# Application to modify a development consent

Fern Bay Seaside Village

MP No. 06\_0250 - Residential subdivision (Approved 28 June 2010)

**SECTION 75W REQUEST TO MODIFY THE MINISTER'S APPROVAL OF PROJECT  
APPLICATION 06\_0250 (28 JUNE 2010) – SEASIDE BOULEVARD, FERN BAY  
MODIFICATION SOUGHT COMPRISES DELETION OF TWO CONDITIONS**

**ATTACHMENT 1**  
**– PLAN SHOWING LOCATION OF PATHWAY ON NELSON BAY**  
**ROAD**

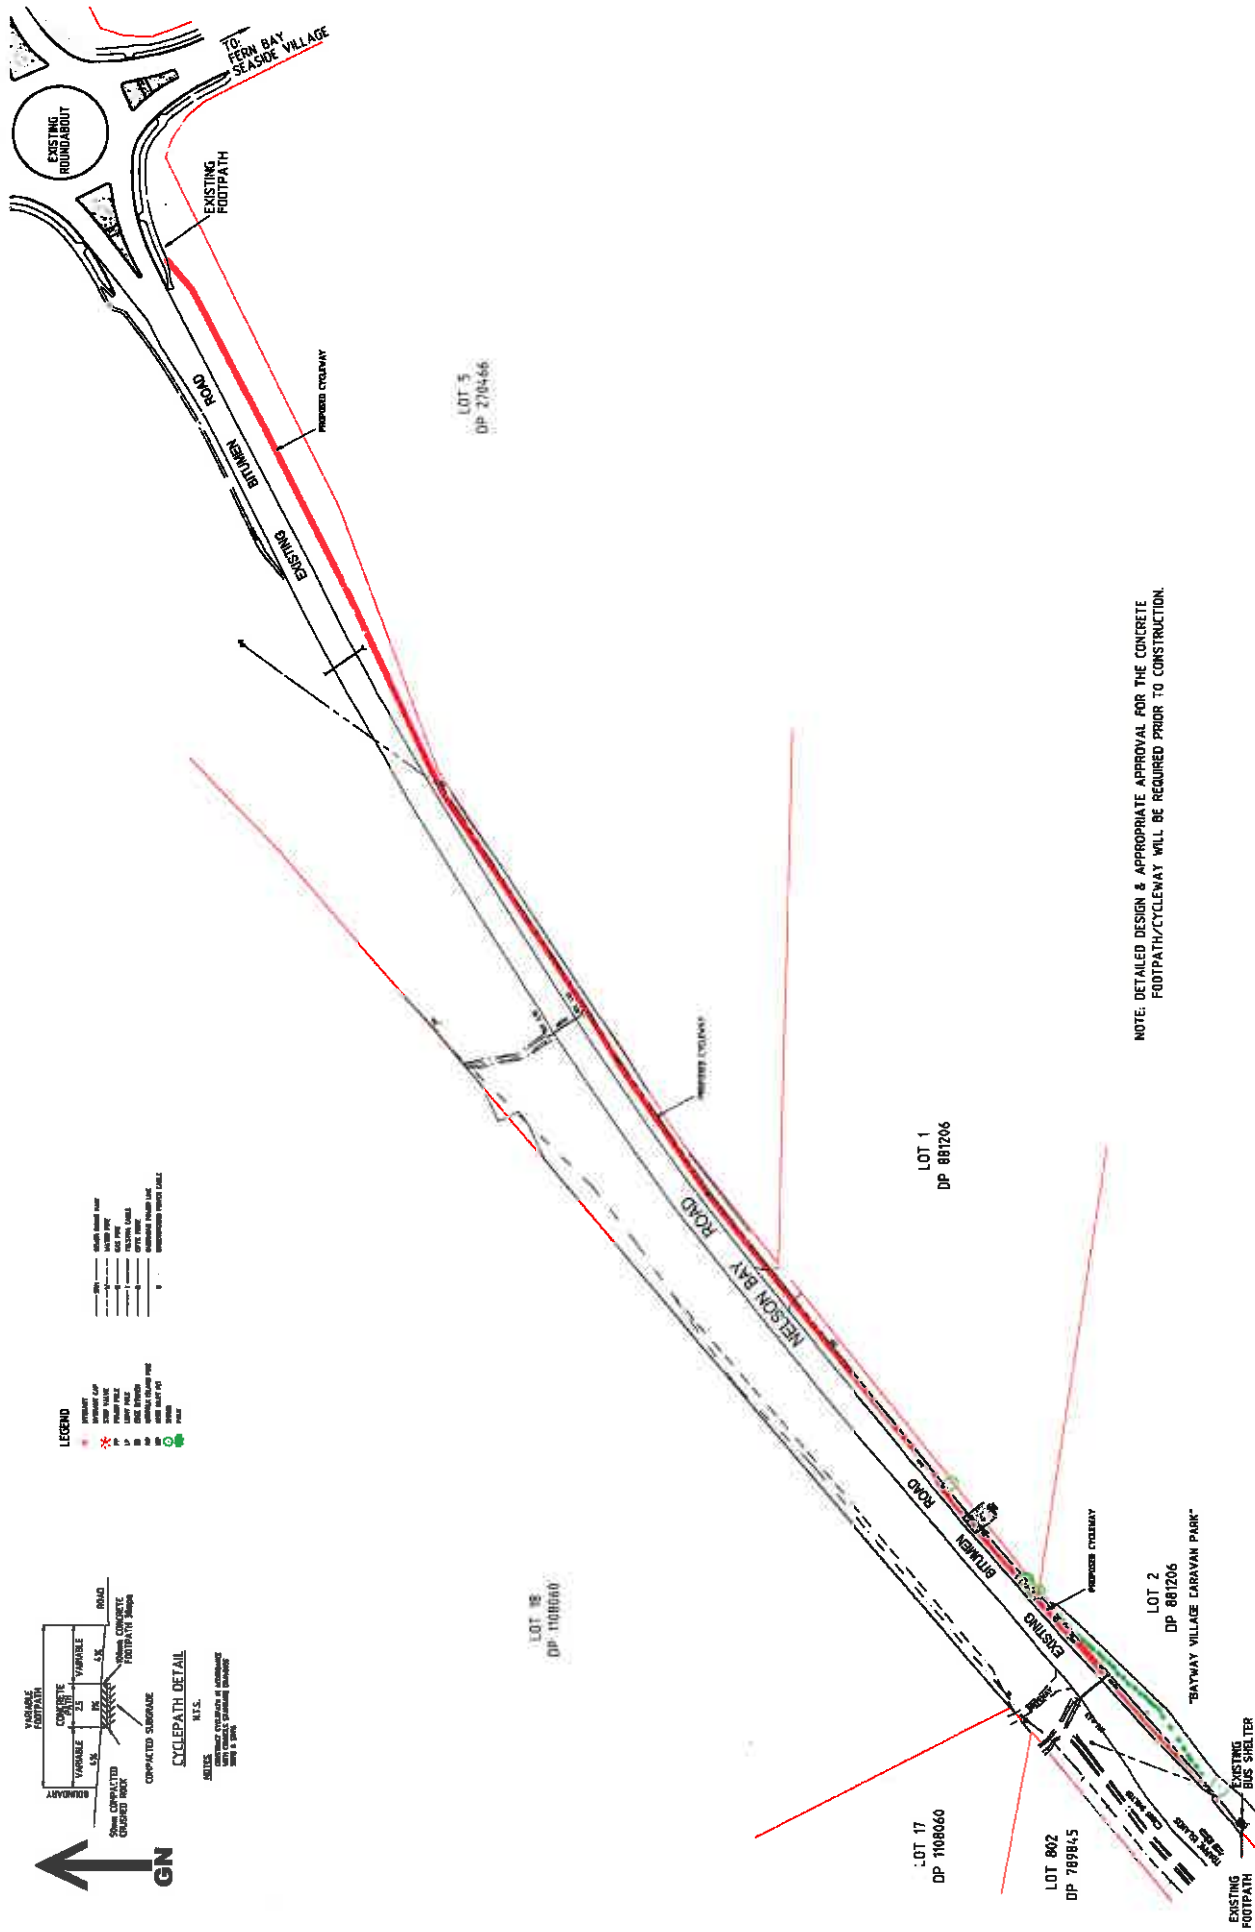
The proposed route of the shared footpath / cycleway is illustrated in the attached plan by North Point Surveys – *Footpath & Cycleway Rev F* (sheet 20 of 23 of the approved drawings dated 20/12/2013). The Plan illustrates that the route passes adjacent to and partially through land owned by Bayway Village Retirement Park.

- It is understood that Nelson Bay Road is a road under the control of RMS. There is insufficient width in the existing reserve to accommodate a shared footpath/cycleway and its provision is not accommodated in RMS's designs for the road.

- The Port Stephens Council originally sought for the condition to be imposed assuming construction of the facility would be relatively straightforward.

- Rawson Communities recently met with representatives of Port Stephens Council, namely the Mayor and Matthew Brown (Manager Development Assessment and Compliance) to discuss the requirements to meet the condition. It was agreed at the meeting that, for Rawson Communities to be able to deliver the footpath/cycleway and thus comply with the condition, Council would need to acquire some land from an adjoining landowner, Bayway Village Holiday Park. Bayway Village does not wish to sell this land to the Council and are not supportive of the cycleway.

- Both the developer and the Council have attempted many times to acquire the land off Bayway Village but these negotiations have been unsuccessful. The Council does not wish to compulsorily acquire the land simply to accommodate this section of pathway.

- The Council acknowledges that the ability to comply with this condition of approval is therefore out of the control of Rawson Communities and that it is unreasonable to delay future stages of the Fern Bay estate because of this inability to deliver the shared footpath/cycleway.

- Rawson Communities sought Council's views on the condition being removed. It was agreed that the condition would be removed and that the Council would support this by way of a s75W modification accordingly.

- Cardno notes that there is a shared pathway already constructed for part of this section of Nelson Bay Road but it is located on the opposite (ie northern) side of the road to Seaside Village Estate.

Given that Rawson Communities are unable to comply with this condition due to circumstances beyond their control, and the fact that the Council who sought the original condition now supports its removal, deletion of the condition is requested. Immediate removal is sought as Rawson Communities are soon to construct the 250<sup>th</sup> lot referenced in the condition at which time the requirement to meet the condition is triggered.

FIGURE 2

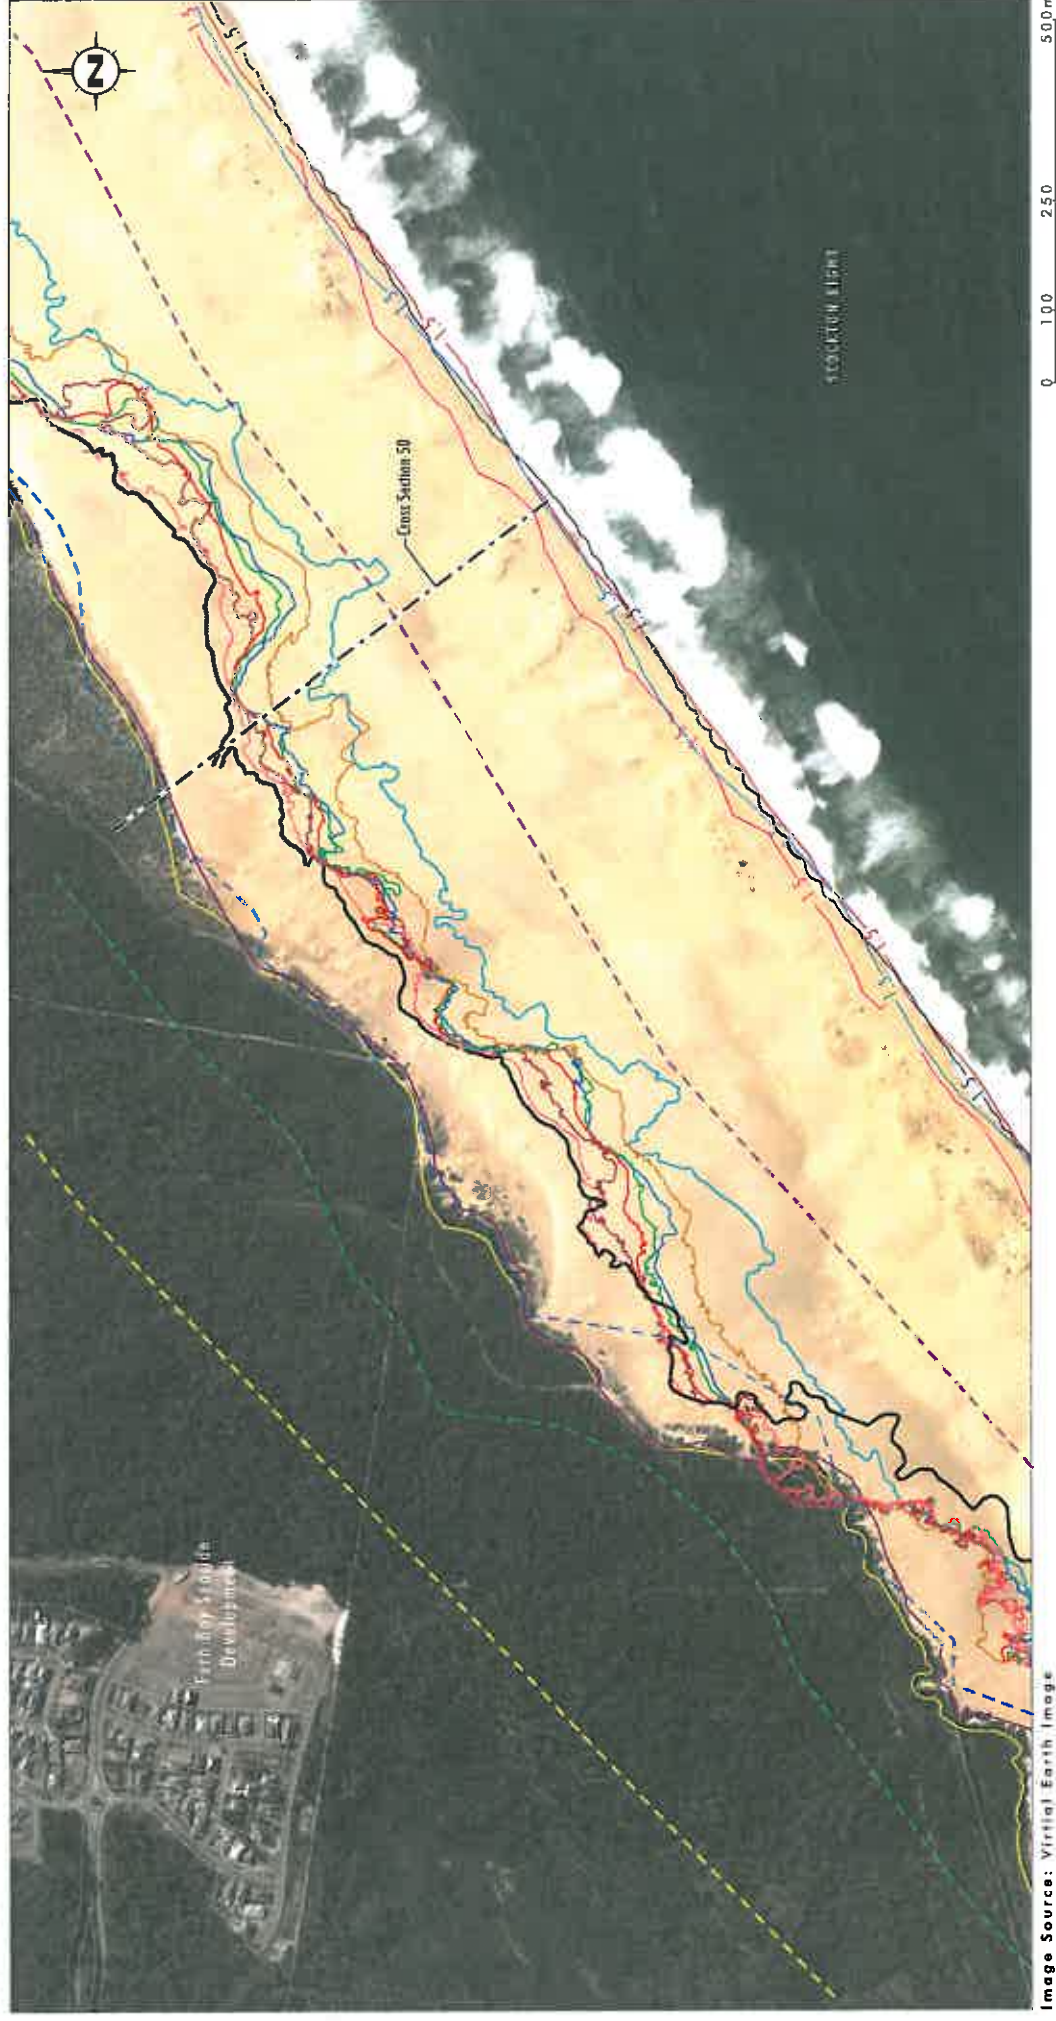
Analysis of available LiDAR derived topographic data for Stockton Bight adjacent to the Fern Bay Seaside development provided on **Figure 2** shows that the shoreline has aggraded (i.e. moved seaward) between 1954 and 1994 and remained in approximately the same location between 1994 and 2007. Analysis (see **Figure 2**) shows that 2007 shoreline at 1.5 mAHD (approximately high water mark) is shoreward of the 1954 location by approximately 20 to 50 metres. Analysis of the 2013 LiDAR data shows that the shoreline has in places receded since 2007 but is still typically 25 metres seaward of the shoreline location in 1954. This indicates the beach has aggraded by approximately 25 metres over the 60 year period since 1954 which equates to an average rate of approximately -0.4 metres per year. This is compared to the 1.2 metres per year beach recession rate predicted in the AWACS 1992 report and used in deriving the estimate of beach recession set out in **Table 1**. Based on this analysis, the 100 year beach recession component set out in **Table 1** could be reduced to between 0 metres and -20 metres rather than the +120 metres that was used by AWACS (1992) in deriving the 100 Year Dune Hazard Line shown on **Figure 1**.

As shown on **Figures 2 and 3**, LiDAR data from January 2007 and June 2013 has been used to plot the landward edge of the transgressive dune system. The location of the landward edge of the transgressive dune system was compared to the August 1991 location plotted by AWACS. This information was then used to determine average annual rate of transgressive dune movement over a 2400 metre length of the dune system adjacent to Fern Bay Seaside development. Based on this analysis the average annual rate of landward movement of the transgressive dune system between August 1991 and January 2007 was approximately 1.1 metres per year. As noted above, during this period (i.e. between 1997 and 2002) mining operations moved the dune system approximately 50 metres to 80 metres seaward.

The analysis provided on **Figure 2** shows that the rate of landward dune transgression has reduced with the current landward edge of the unvegetated mobile dune system in approximately the same location as plotted by AWACS in 1992. In addition, the heavy mineral sand mining activities that occurred between 1997 and 2002 moved the mobile dune mass seaward of its 1994 location. At the same time, the height of the major hind dune system was lowered by approximately 2 to 3 metres and the small dune system between the hind dune and the Fern Bay Seaside development site was also lowered by approximately 5 metres. As a result of these changes that were undertaken as part of the heavy mineral sand mining activities, the potential for sand to be transported onto the Fern Bay Seaside development site has been substantially reduced.

FIGURE 3

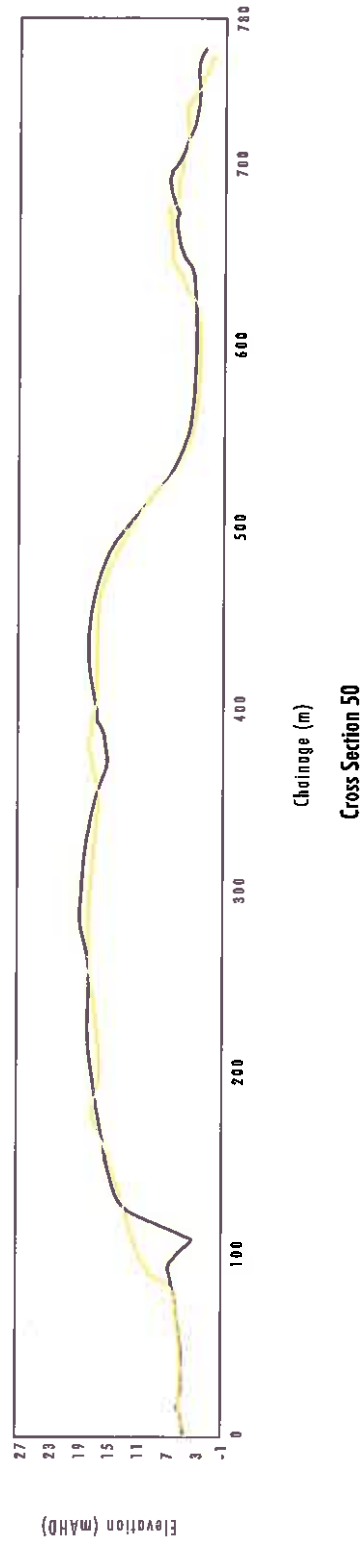
Comparison of the landward edge of the dune system in January 2007 and June 2013 indicates that the dune system has moved on average approximately 2.3 metres per year over the 2400 metre length of the dune system adjacent to Fern Bay Seaside development that was analysed.

progression between 2007 and 2013 was on average 2.3 metres per year which is consistent with that observed between 1983 and 1994.
